V2500-A5 SERIES PROPULSION SYSTEM NON-MODIFICATION SERVICE BULLETIN

NON-MODIFICATION SERVICE BULLETIN – REPLACEMENT OF PRESSURE KIEL TAPS IN THE TURBINE EXHAUST CASE (TEC) TO IMPROVE THRUST AND ENGINE PRESSURE RATIO (EPR) PERFORMANCE CHARACTERISTICS

V2500-ENG-72-0610

LOCATION OF THE TURBINE EXHAUST CASE ASSEMBLY AND REPLACEMENT
OF THE PRESSURE KIEL TAPS, 72-50-53
FIGURE 1, SHEET 1

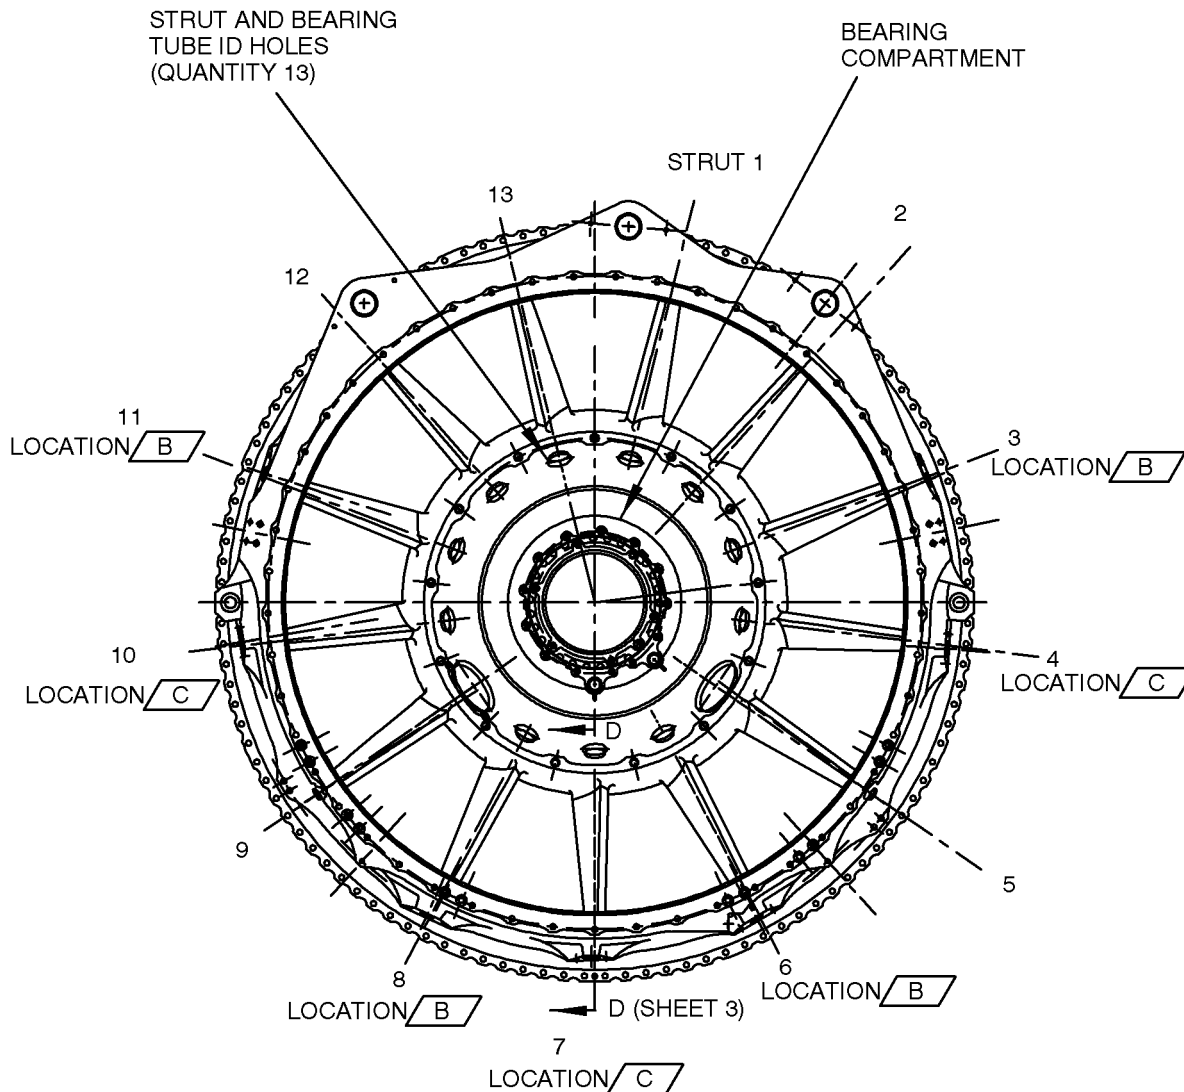
- (2) Disassemble the TEC assembly shown in Figure 1, Sheet 1 by the procedure in Reference 2, Engine Manual, Task 72-50-50-040-001-C00, Disassembly.
- (3) Perform all TEC cleaning and inspection procedures. See Reference 2, Engine Manual, Task 72-50-53-100-002-B00, Cleaning-02; Reference 3, Standard Practices Manual, Task 70-50-53-200-003-B00, Inspection/Check-03

LOCATION OF THE TURBINE EXHAUST CASE ASSEMBLY AND REPLACEMENT
OF THE PRESSURE KIEL TAPS
FIGURE 1, SHEET 2

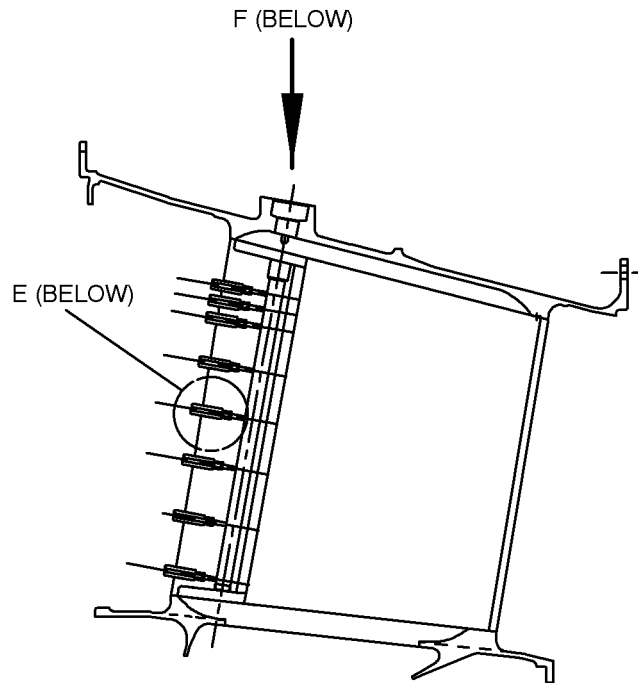
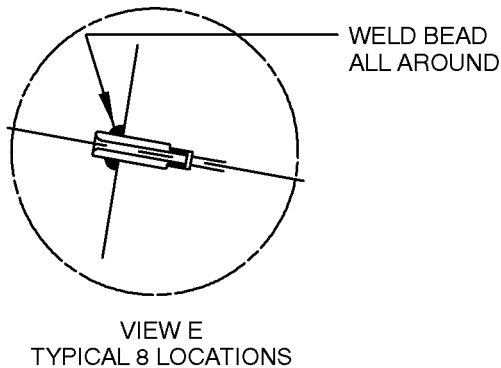
- (4) Mask the bearing compartment, the bearing tube Inside Diameter (ID) holes at Struts 5 and 9, the ID holes at Struts 1 - 13, and Struts 3, 6, 8 and 11 at Location B in Figure 1, Sheet 2 to prevent contamination from machining operations. Use mechanical covers and tape. See Reference 3, Standard Practices Manual, SPP Task 70-38-24-300-503, Mask the Parts 03.

- (5) Machine to remove material from 24 pressure kiel taps to 0.000 - 0.020 in. (0,00 - 0,51 mm) above the strut leading edge on Struts 4, 7 and 10 at Location C in Figure 1, Sheet 2. Do not remove strut parent material.

- (b) Insert the borescope through the external bosses on the case at Location C in Figure 1, Sheet 2.
 - (c) If you find machining chips or coolant, then clean the TEC again by the procedure in Reference 3, Standard Practices Manual, Task 70-11-03-300-503, Aqueous Degrease 03. Thoroughly flush all cavities, strut openings and the bearing compartment.

LOCATION OF THE TURBINE EXHAUST CASE ASSEMBLY AND REPLACEMENT
OF THE PRESSURE KIEL TAPS
FIGURE 1, SHEET 3

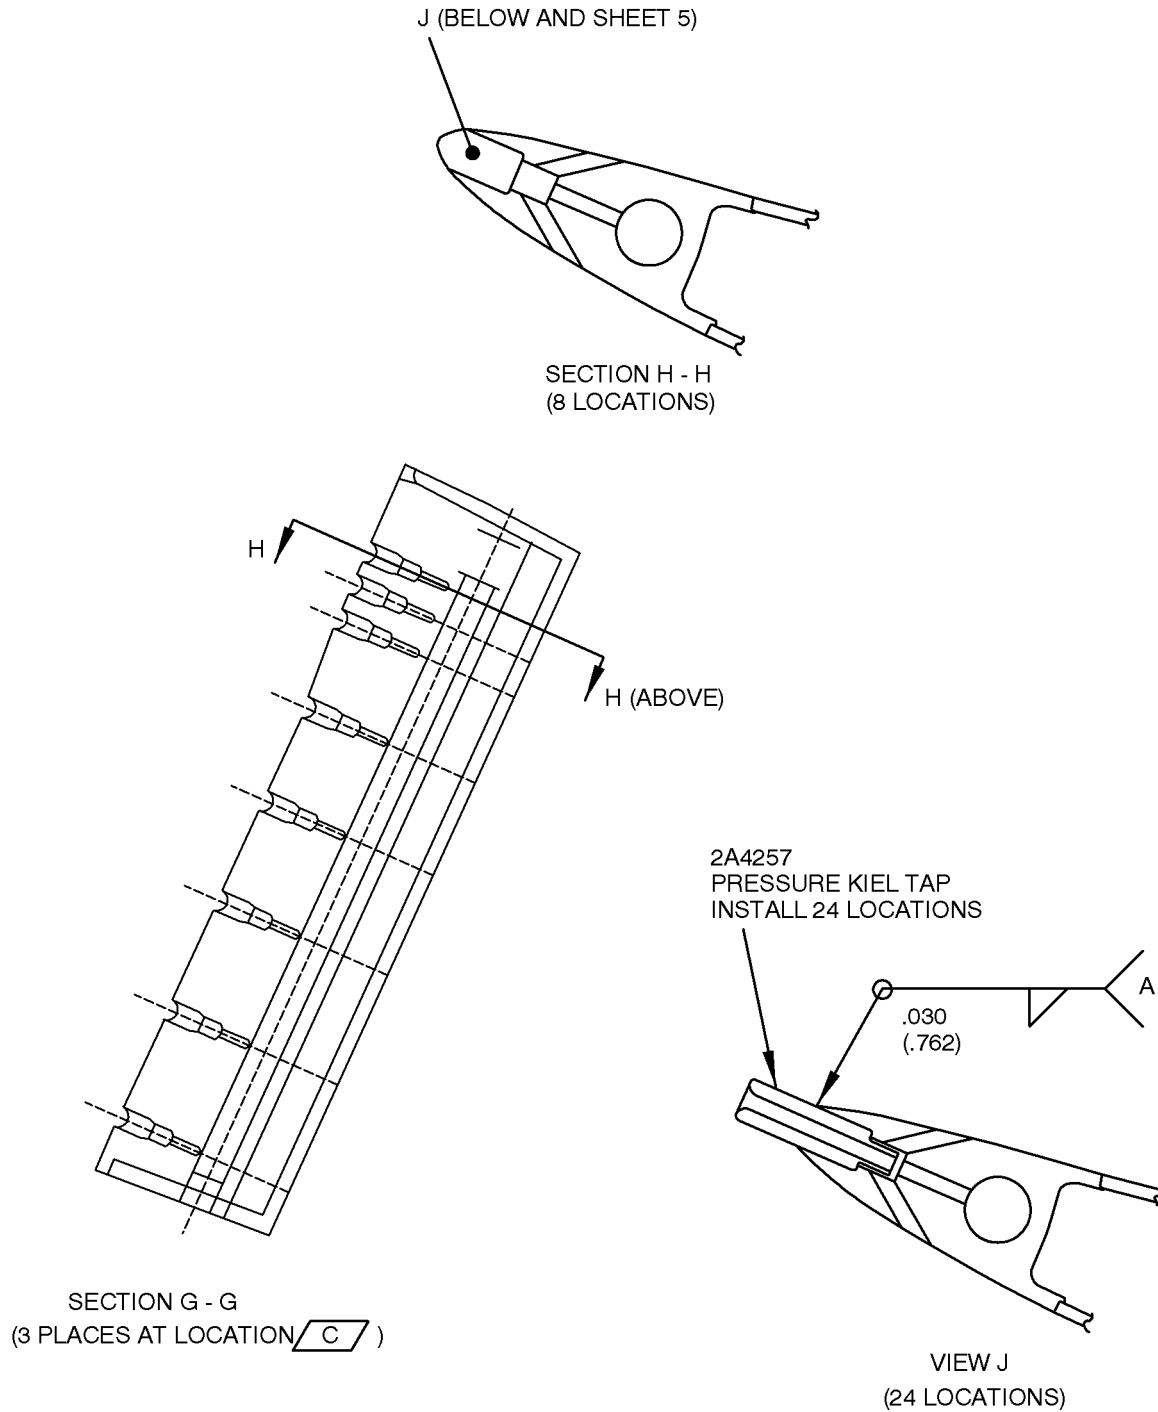
- (16) Install 24 new Pressure Kiel Taps, PN 2A4257, on the struts and weld them to the struts. Use CoMat 03-378 Welding Wire and the Gas Tungsten Arc Weld (GTAW) method. See Reference 3, Standard Practices Manual, SPP Task 70-31-13-310-501, Fusion Welding, except the theoretical throat requirement is waived. Actual throat shall be 0.020 in. (0,508 mm) minimum. Refer to Figure 1, Sheets 3 and 4.

LOCATION OF THE TURBINE EXHAUST CASE ASSEMBLY AND REPLACEMENT
OF THE PRESSURE KIEL TAPS
FIGURE 1, SHEET 5

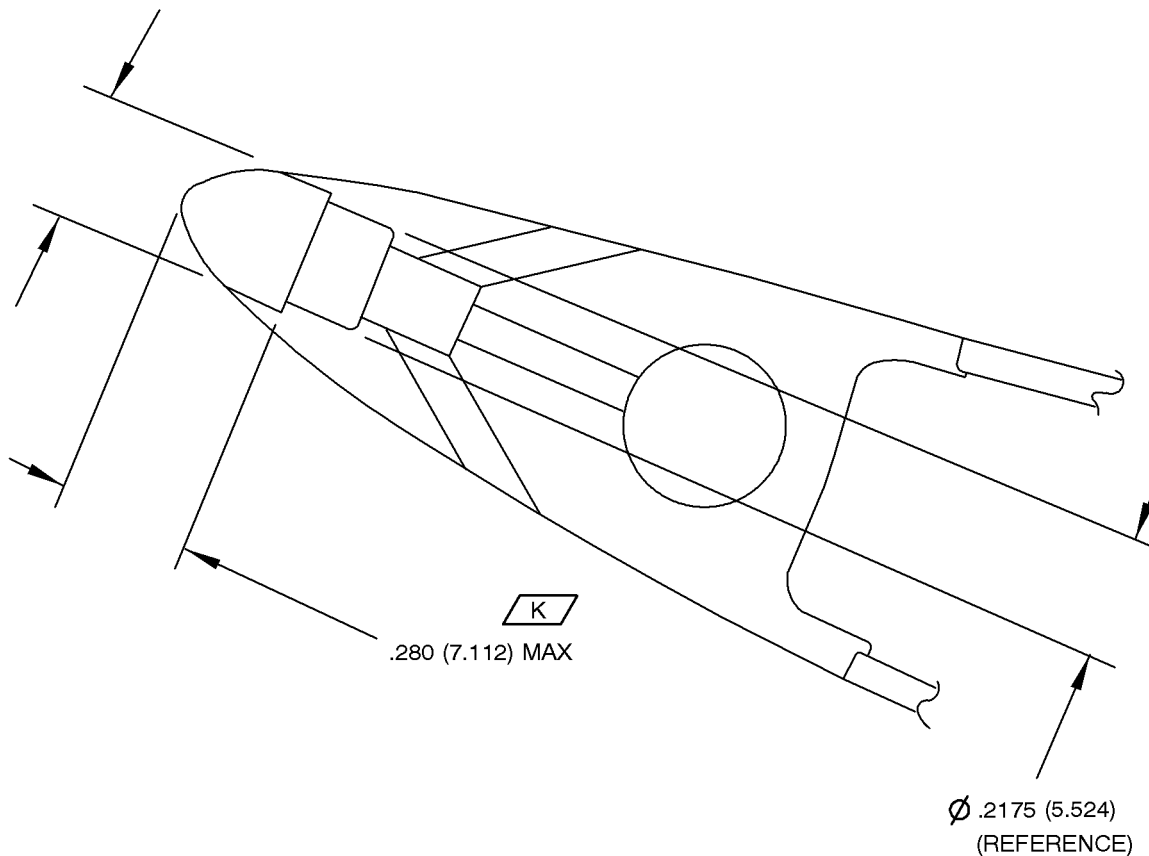
- (8) Partially remove the 24 pressure kiel taps by machining a 0.238 in. (6,045 mm) diameter hole to 0.280 in. (7,112 mm) maximum depth at each pressure kiel tap location. Locate the center of the 0.238 in. (6,045 mm) diameter hole using the center line of the existing 0.2175 in. (5,524 mm) diameter hole. See Figure 1, Sheet 5.

- (13) Break all edges/corners 0.003 - 0.015 in. (0,08 - 0,38 mm), except as shown in Figure 1, Sheet 5.
- (14) Locally clean affected areas. See Reference 3, Standard Practices Manual, Task 70-11-26-300-503, Solvent Cleaning 03.

DIAMETER .238 (6.045) MAXIMUM PERMISSIBLE FOR DISTANCE K
BREAK-EDGE REQUIREMENT WAIVED ON EDGE SURFACE,
CONSUMED DURING WELD.
